Appendix E

Comment Letters and Reclamation's Response to Comments
Set 5 of 5 (pages 90-141)

DWR Monitoring Data for Wells Located Near Proposed Production Wells of 4-S Ranch and SHS Ranch

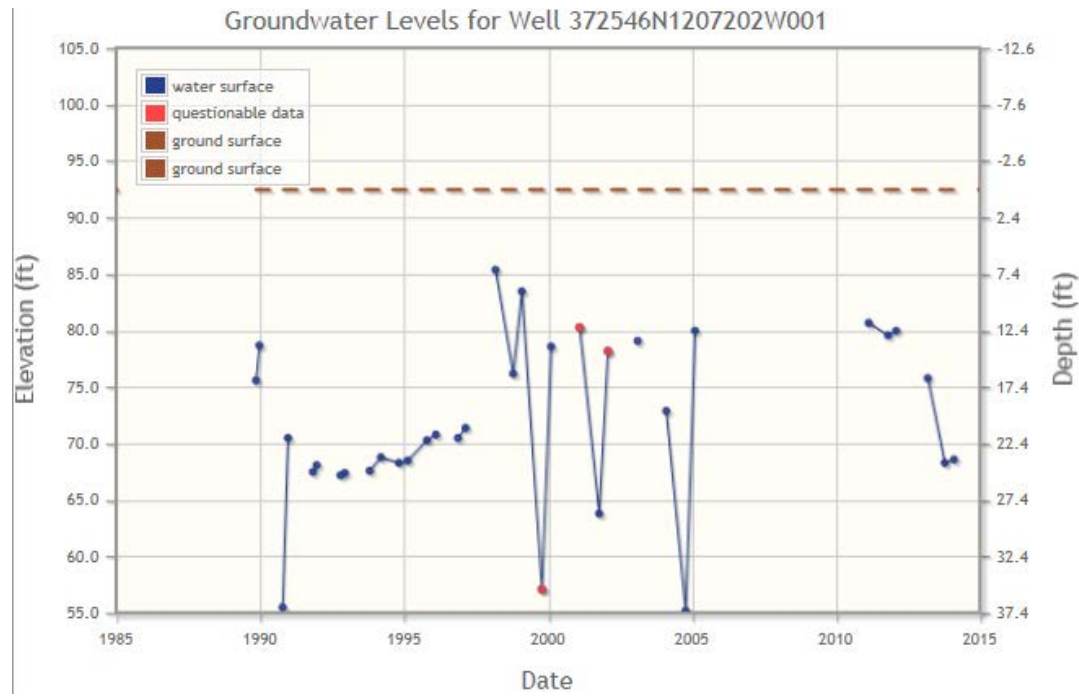
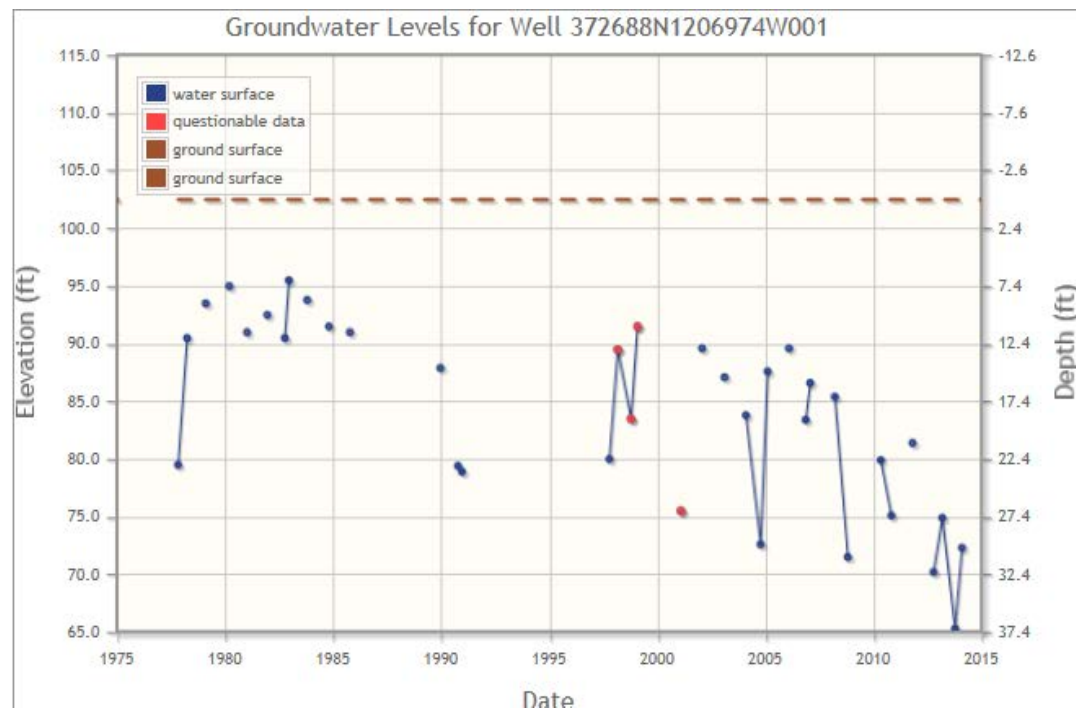
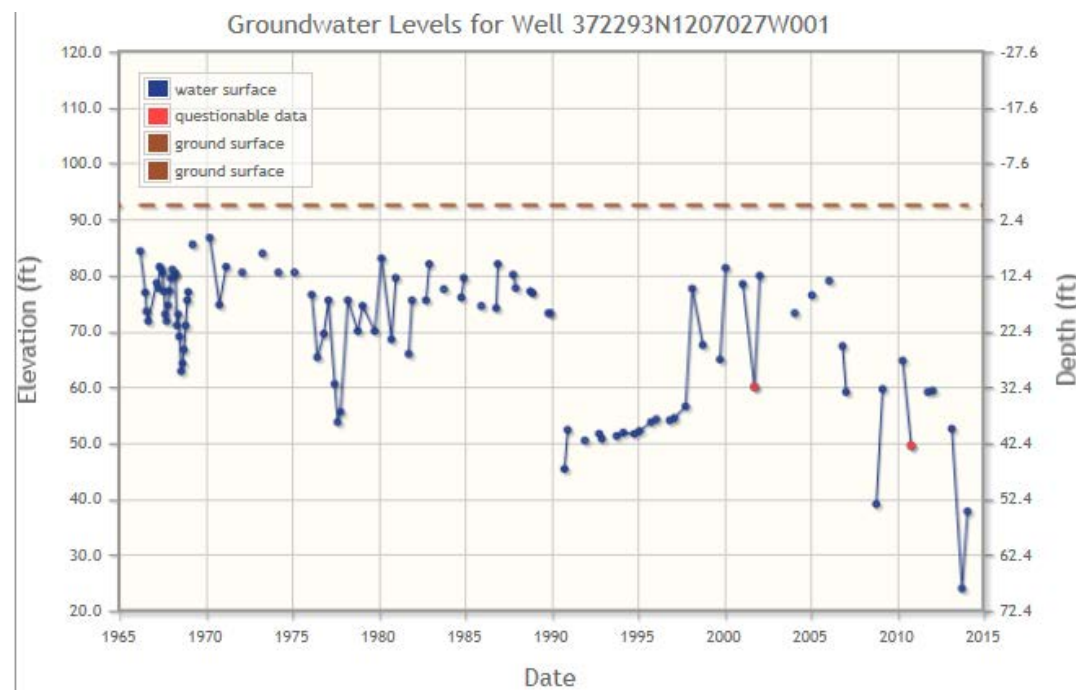
Attached are plots of groundwater levels at three wells located near the proposed participating production wells identified for the proposed project (*Attachment 1*). These three wells were selected in order to identify readily available monitoring data near the proposed participating production wells with several years of data through the current year. The first plot identifies groundwater levels measured at a well located within approximately 1,000 feet of Production Well #3 during 1989 through 2014; and the data indicates that current levels are near levels reported following the last major drought period of the late 1980’s and early 1990’s, with increased groundwater levels in the interim.

The second plot identifies groundwater levels measured at a well located within approximately 1.6 miles of Production Well #3 during 1977 through 2014; and the data indicates a decreased trend in groundwater levels, particularly during the past eight years. The third plot identifies groundwater levels measured at a well located within approximately 300 feet of Production Well #8 during 1966 through 2014; and the data indicates a decreased trend in groundwater levels, also particularly within the past eight years.

The second and third plots also identify groundwater level measurements obtained on October 15, 2013 were the lowest levels measured at those sites for the periods of record. Based on the data, the draft environmental documents need to further analyze potential impacts to groundwater levels as a result of the proposed project; and identify how the proposed project will not further decrease groundwater levels that appear to be already decreasing more significantly within the past eight years as compared with historical levels.

- MCFB-20** See Response to MCFB-1.
- MCFB-21** As noted above, a monitoring plan has been developed to monitor groundwater levels, water quality, and subsidence during the duration of the Proposed Action (see Appendix F in the Final EA). The document referenced in the comment is for a different type of transfer proposal and is not applicable to the Proposed Action considered here.
